Nacton 4m transverter Upgrade modifications

G4DDK Revision0.2 8/02/2014

Photo 1. Modified Nacton 4m transverter mounted in the screened tinplate box used for testing. Resistors R37 and R38 are shown circled in red. The PIN diode changes are shown circled in yellow. The thin red wires are the Post mixer amplifier and the R35 modifications.

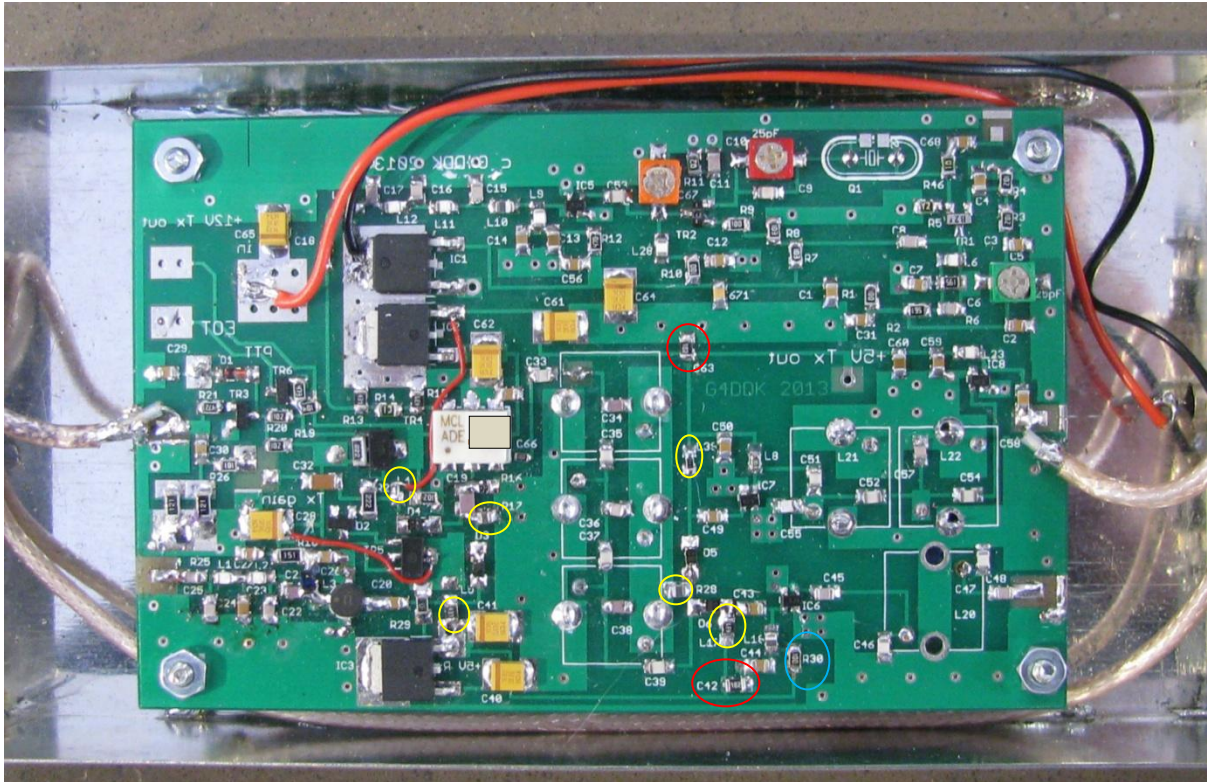
The second improvement comes from changes in the PIN diode switching. The original arrangement was found to add a small amount of noise into the IF signal path. This noise comes from Zener diode D2, amplified by TR5.

The changes involve some cut and strap modifications.

1. Carefully unsolder R17 (430R) and place on one side
2. Carefully unsolder L5 and move it to the pads previously occupied by R17
3. Now solder R17 between the original signal track pad occupied by L5 and the large adjacent +5v regulator output pad next to C41.

This simple modification will improve receiver sensitivity by several dB. The changes are shown in Photo 1 circled in yellow, and include the next few changes as well.

It is now necessary to do the following modification to restore transmit operation and as a by-product, further improve receiver sensitivity.

Unsolder L4 and placed on one side.

Solder a 430R resistor to the vacant L4 pad that connectors to D4. Do **not** solder the other end to the other pad. Instead you should solder the end of a short length of insulated wire to the free end of the resistor (called R35) and the other end should be soldered to the +5v output pin pad of IC3.

This modification ensures D4 is turned off completely on receive. If it is not then adjusting the transmit gain pot, R27, affects the receiver gain due to signal leakage through D4 and the pot to ground.

The reverse bias on the PIN switching diodes is not well defined. Adding 1K resistors (R37 and R38) across the transmit and receive +5V supplies is an easy solution to this problem.

For convenience R37 is connected across C671 (near the centre of the board) and R38 is connected across C42 (near IC4) as shown in photo 1, circled in red.

Fig 2. Switching the post mixer amplifier on transmit.

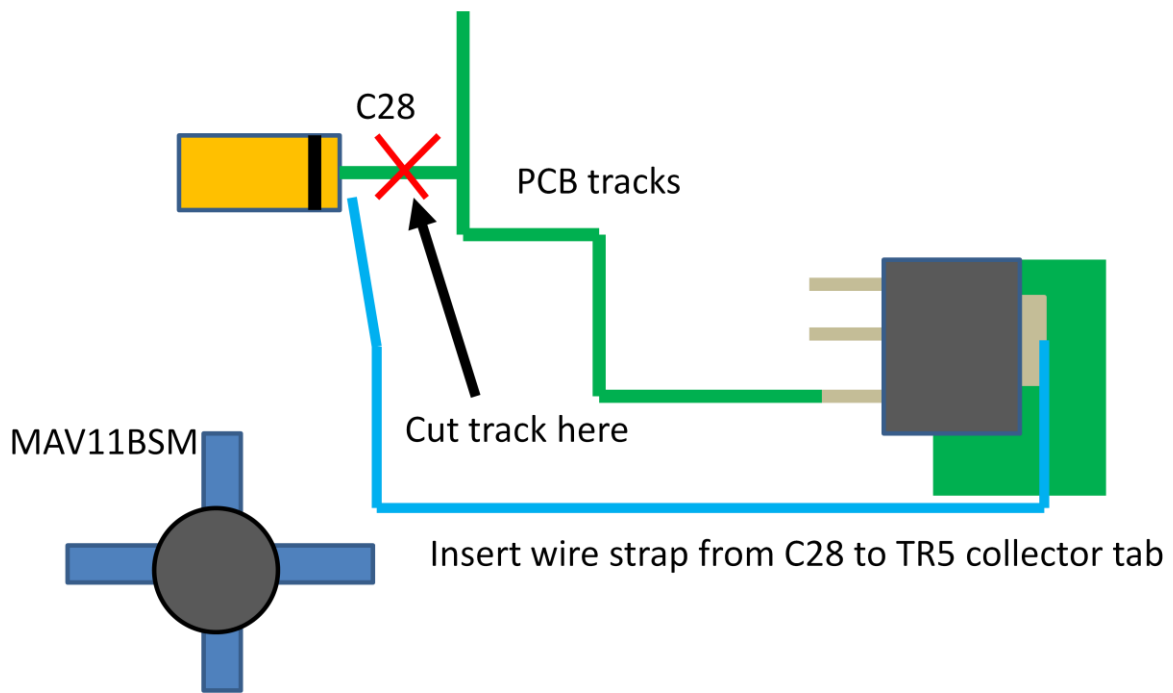
In the previous modification sheet I described how to improve the stability of the receive post mixer amplifier by taking its supply from the switched (input) side of IC2. This information is repeated in this sheet for completeness.

Cut the short track between C26 and TR5. Solder a short, insulated, wire between the positive end of C26 and the collector tab of TR5, as shown in Fig 2, below.

New Nacton 4m schematic circuit diagram incorporating test voltages

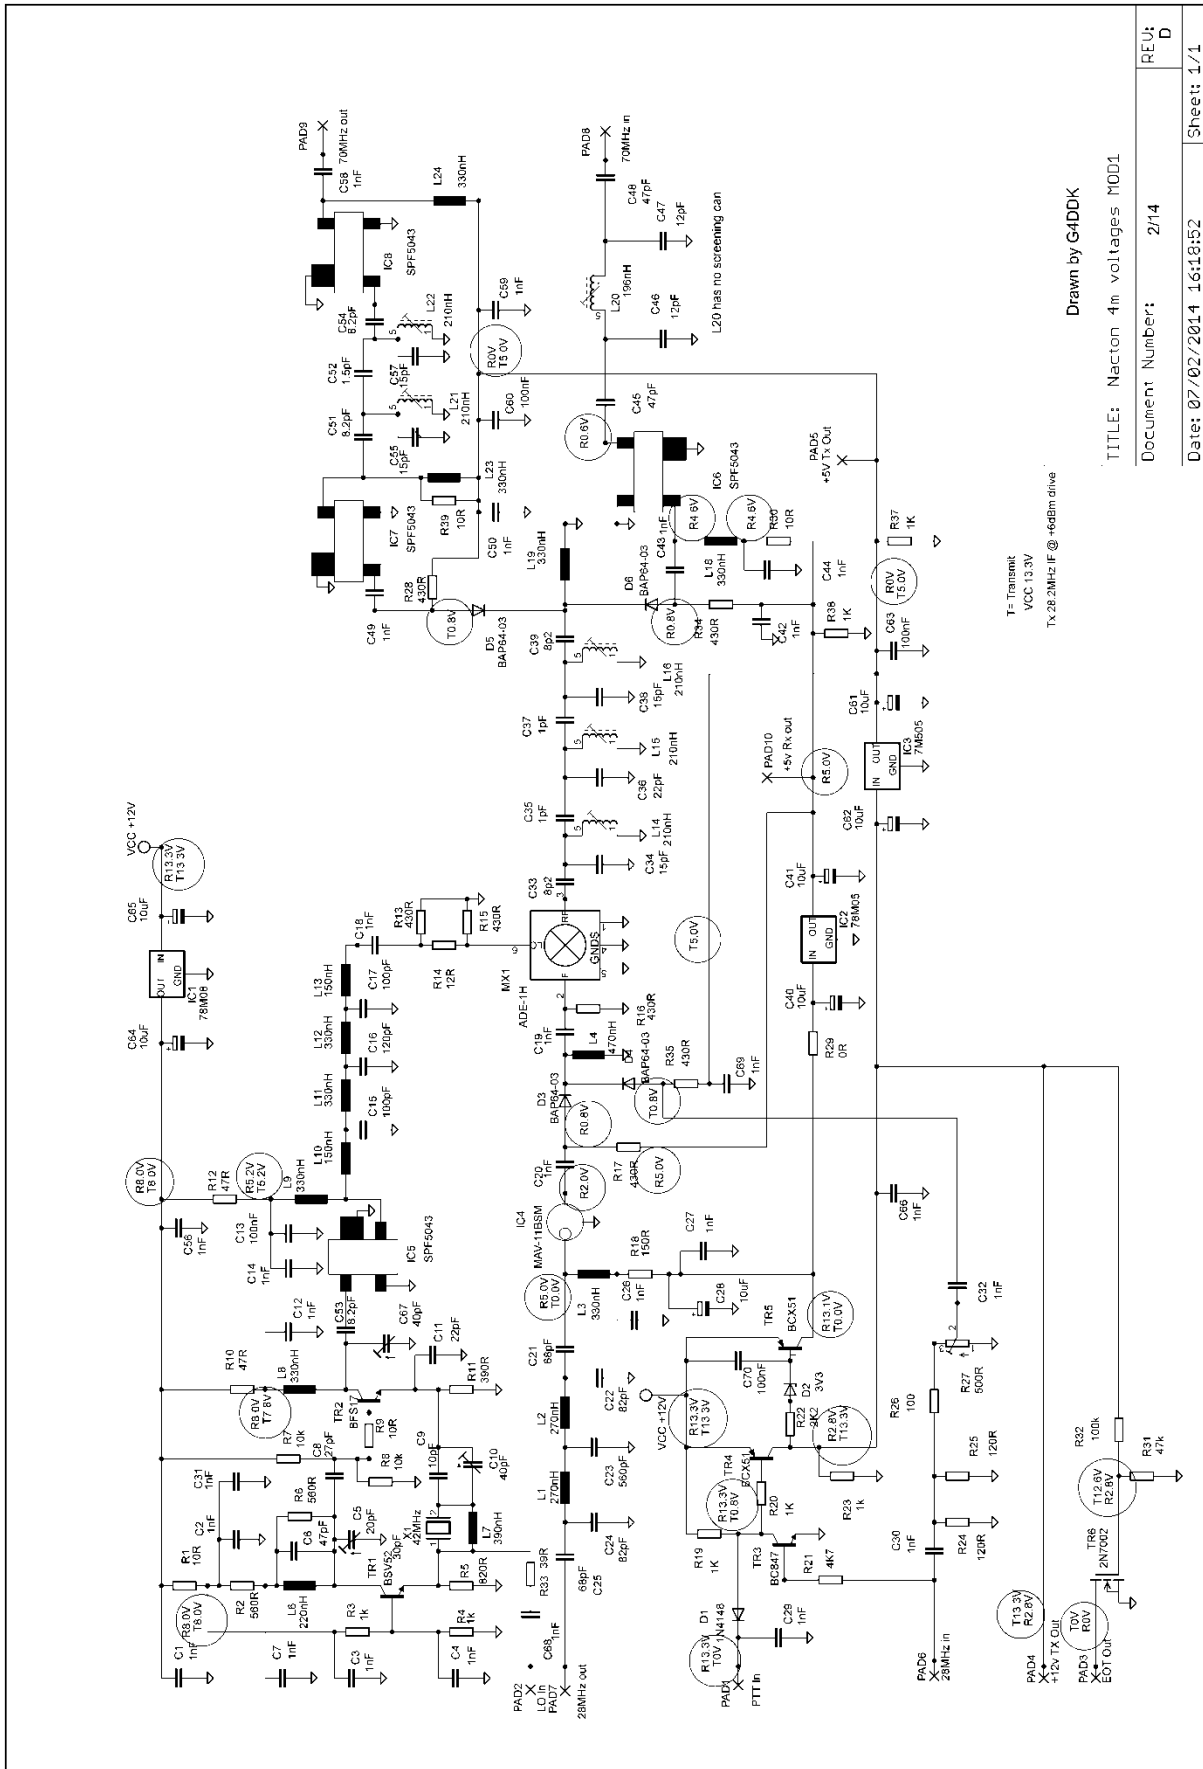
There is a lot of gain in the transmit amplifier chain. By including a 10R resistor (R39) across L23, as shown in the circuit diagram, stability is improved at the expense of requiring slightly more IF drive. Typically the maximum drive requirement goes up from +6 to +10dBm at the 28MHz IF input. R39 should be soldered directly across the top of L23. The position of R39 is shown circled in blue in photo 1.

These are shown circled on the schematic circuit diagram, for both transmit (T) and receive (R).

For transmit the PTT line was earthed and the IF input driven at 28.2MHz with +6dBm with the transmit pot set to minimum attenuation. For receive the input and output should be terminated in 50Ω
